CITY OF CHARLEVOIX
210 STATE ST. CHARLEVOIX, MICH. 49720
PLANNING COMMISSION PUBLIC MEETING AGENDA

SUBJECT: Continued: Site Plan Review: Midtown Development, Inc., 115 Pine River Ln. – Residential Development

Tim Burden
Proposed Residential
SITE AND DIMENSION PLAN
Sections 26 & 27, Town 34 North, Range 8 West
City of Charlevoix, Charlevoix County, Michigan

Figure 4 Enlarged Demolition Plan showing the Protected Tree & Trees to be Removed.

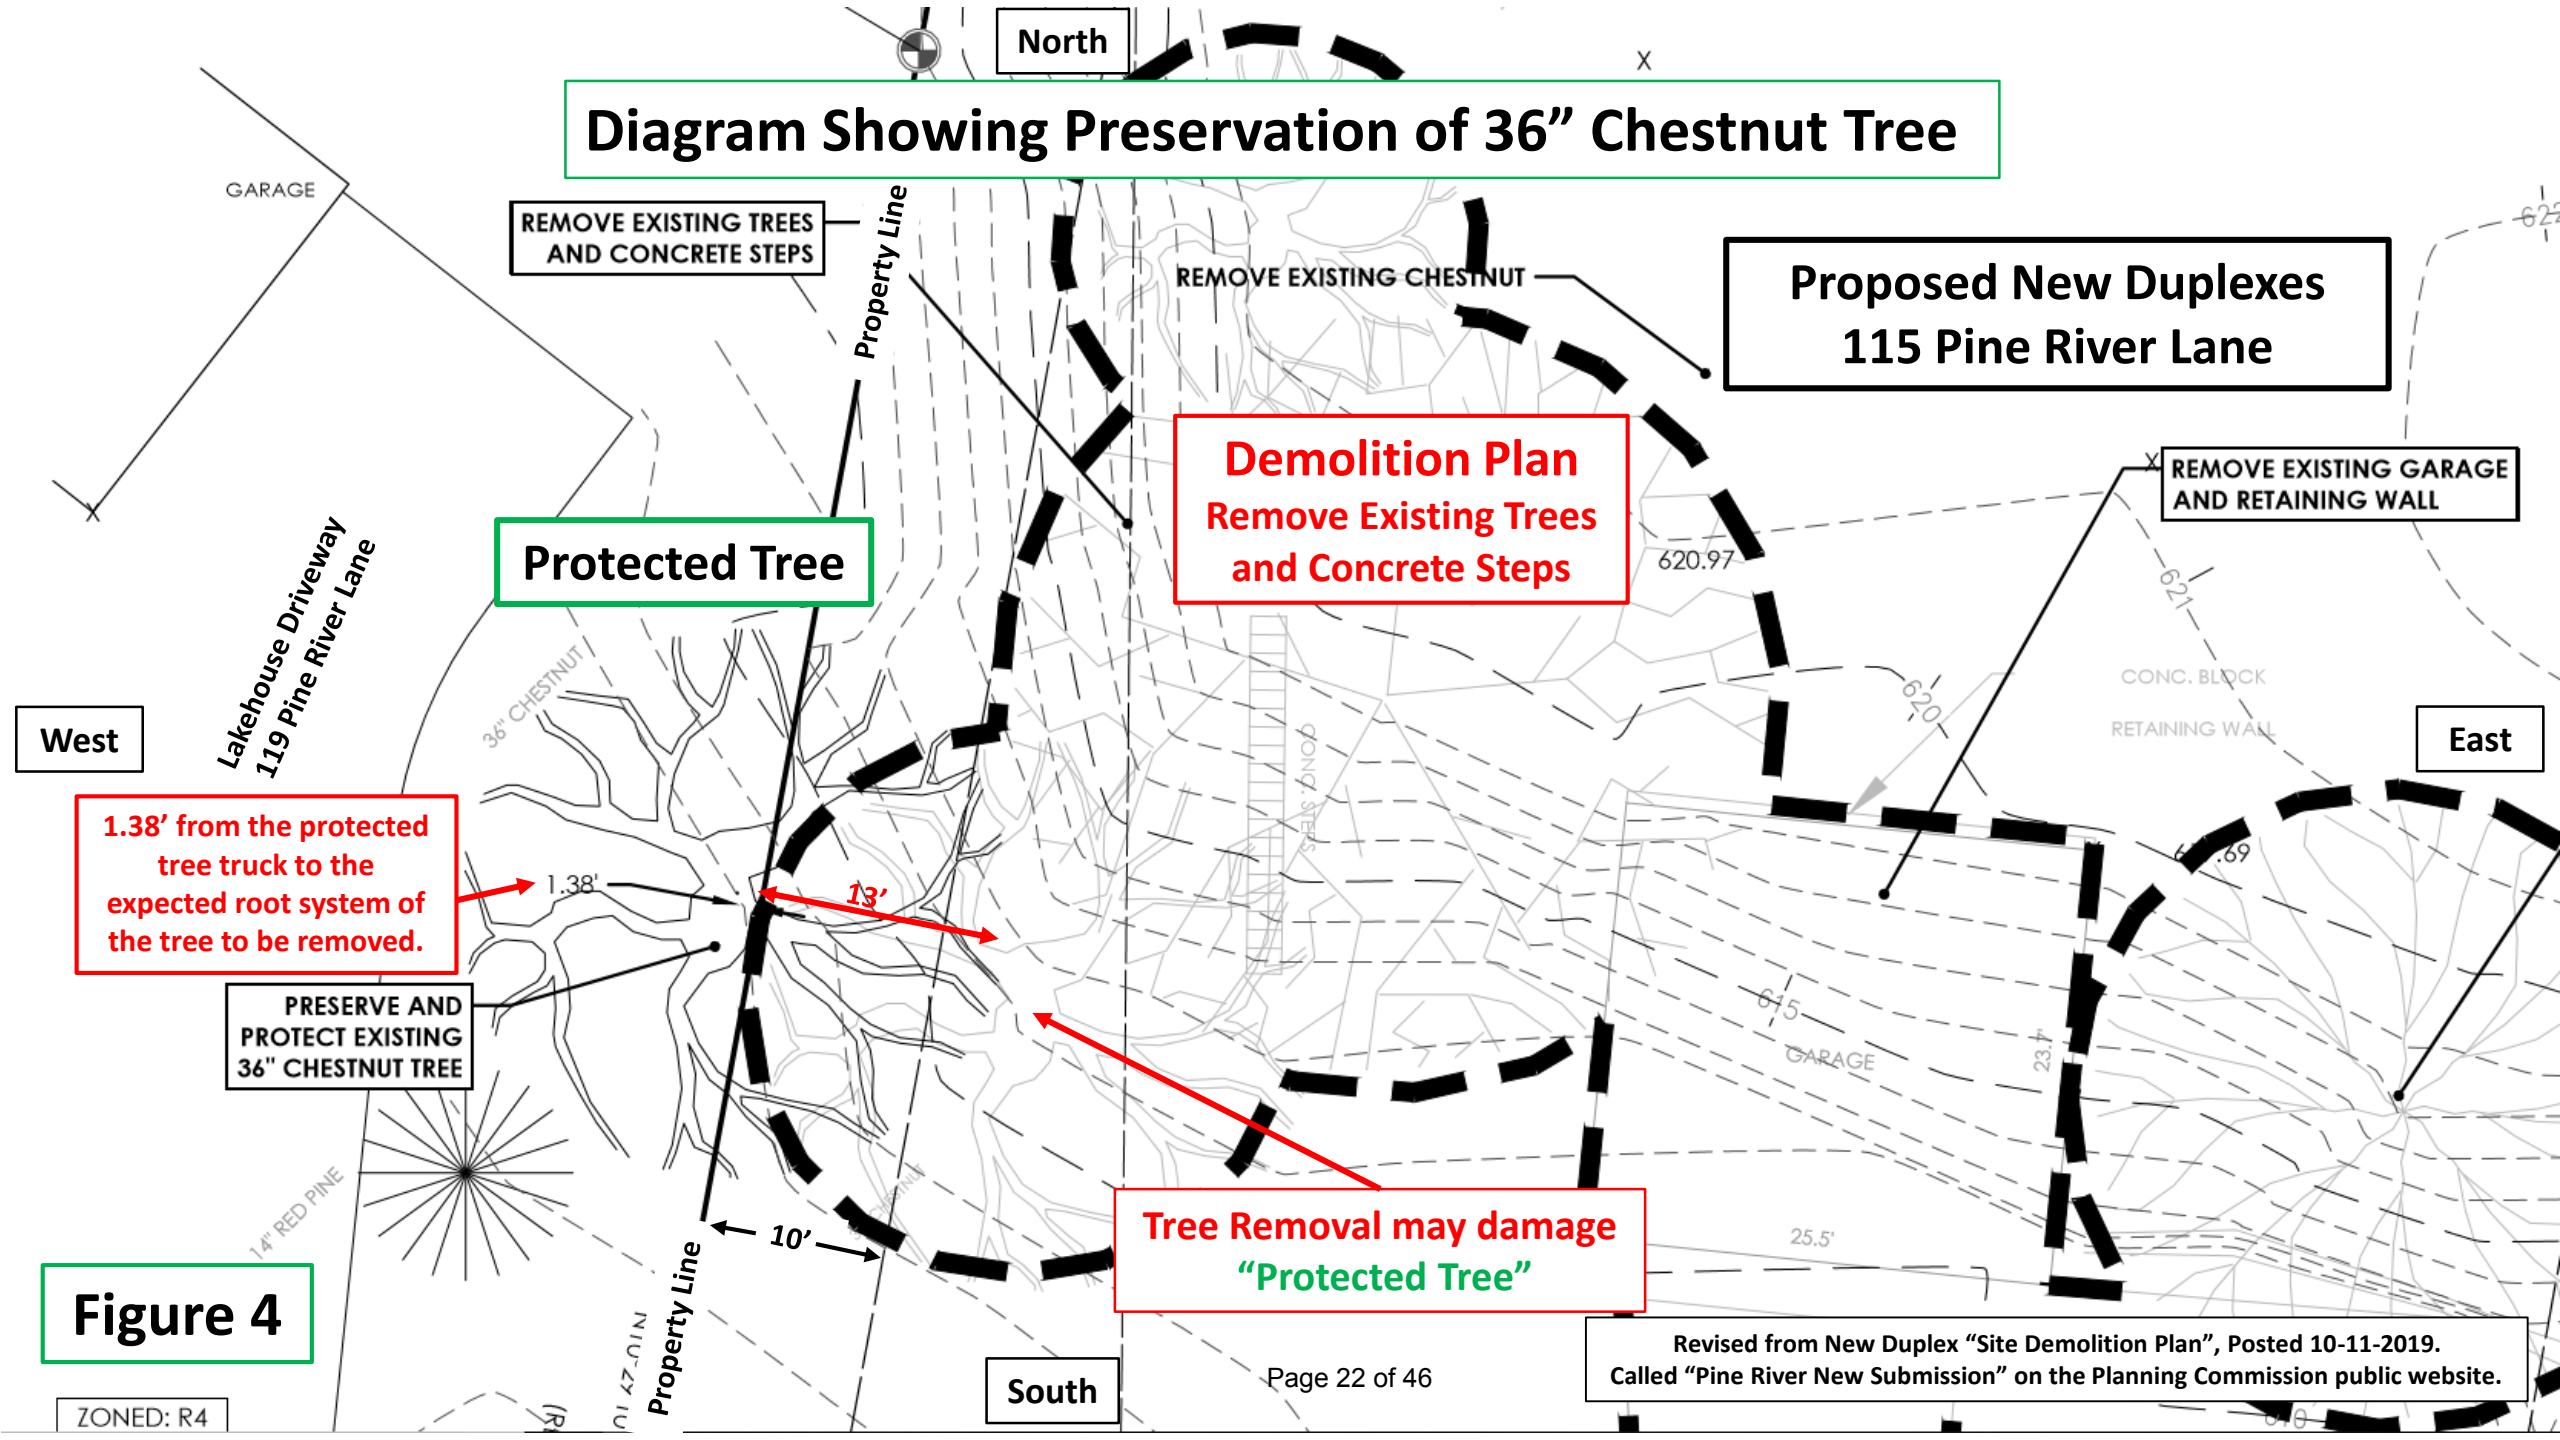
The developer's Demolition Plan shows the Lakehouse Protected Tree, and nearby trees to be removed (Figure 4). One tree to be removed is only 13 feet from the trunk of the Lakehouse Protected Tree and may cause a complication. It shows the expected drip line circumference of that tree (and its expected root system) to be only 1.38 feet away from the trunk of the Lakehouse Protected Tree. **This might mean that the developer intends to dig within the retaining wall boundaries because removal of that nearby tree looks like it has significant root overlap with our tree. An attempt to remove the roots as well as the trunk will probably damage our tree.** Some demolition work has already started (the garage and driveway).

So, the Demolition Plan, as shown, may indicate damage to the root system of the protected tree is possible. And, because the site plan shows a duplex foundation at the location of the tree that will be removed, an extensive root removal plan is apparently planned. Figure 4 is meant to help the Planning Commission understand our concern about that issue. It enlarges the developer's Demolition Plan and makes things more legible. **For example, the tree to be removed is shown in light gray. It's barely visible, and as a result, you are probably unaware of these issues. Because of these facts, I request that the Planning Commission ask for an environmental report, or a report from an expert Arborist, to assess the potential harm to our tree due to excavation in the area of overlapping root systems or within the retaining walls. 153.235 (C) states that the site must be designed to minimize hazards to adjacent property. I request the Planning Commission to obtain that assurance and appropriate guidance to mitigate potential problems identified in that report.**

I am hopeful that when the "planners" get a chance to study the demolition plan (figure 4), they will understand our concerns. At that point, the Planning Commission may want assurance that the plan is designed adequately to minimize hazard to our neighboring property, the Chestnut Tree. So, it is recommended that an expert report be obtained since the demolition work has already begun.

Figure 3 Enlarged Site & Dimension Plan showing the Protected Tree & Retaining Walls.

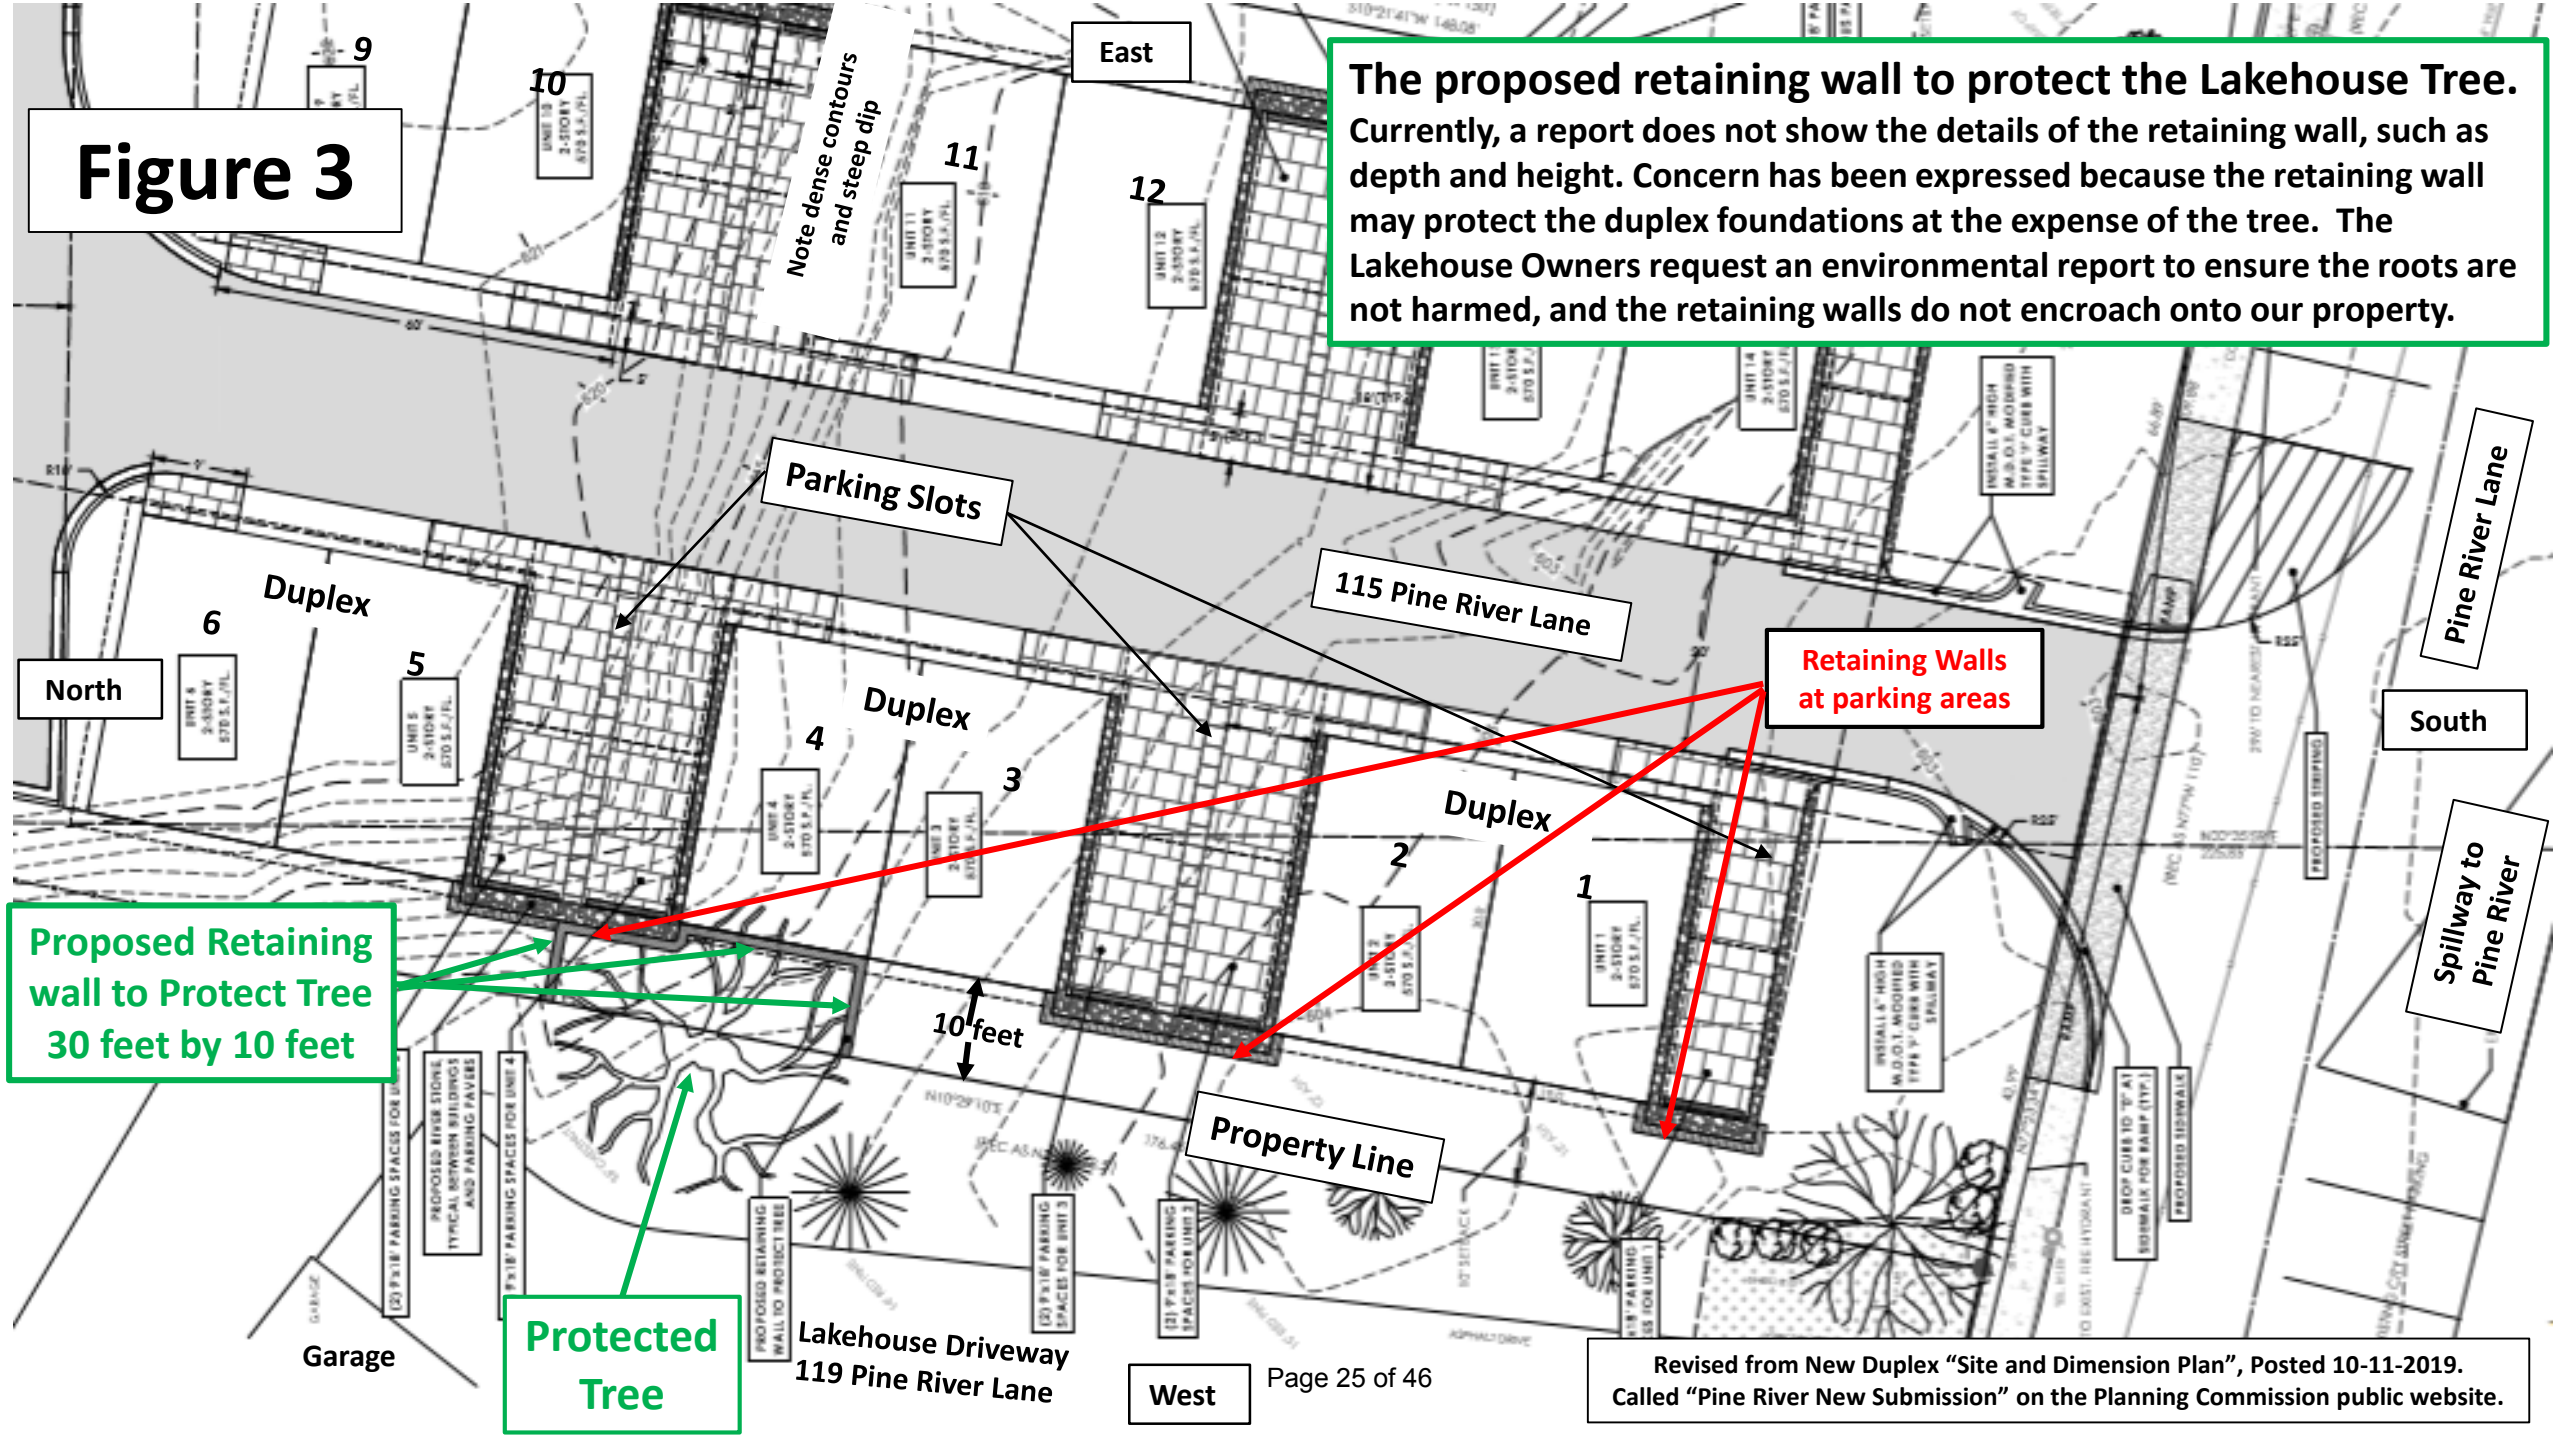
The tree of concern is a 36-inch Chestnut that is just on the Lakehouse side of our property line. It helps stabilize the hillside, and with so many large trees disappearing, our tree plays an important role. The developer realizes some of these concerns, and shows a retaining wall around part of the tree on his "Site and Dimension Plan" (figure 3). Notice that the retaining wall, not only partially surrounds the tree, but goes up to our property line, and to his duplex foundations. It is not surprising that several of owners have expressed concern that the retaining walls may protect the duplex foundations at the expense of the tree. To date, no plans have been provided about the full dimensions of the retaining walls or planned excavations in that area. This is summarized in figure 3 which is an enlargement that shows the relationship of the tree, the duplexes, the parking areas, and the retaining walls.

The proposed retaining wall to protect the Lakehouse Tree. Currently, a report does not show the details of the retaining wall, such as depth and height. Concern has been expressed because the retaining wall may protect the duplex foundations at the expense of the tree. The Lakehouse Owners request an environmental report to ensure the roots are not harmed, and the retaining walls do not encroach onto our property.
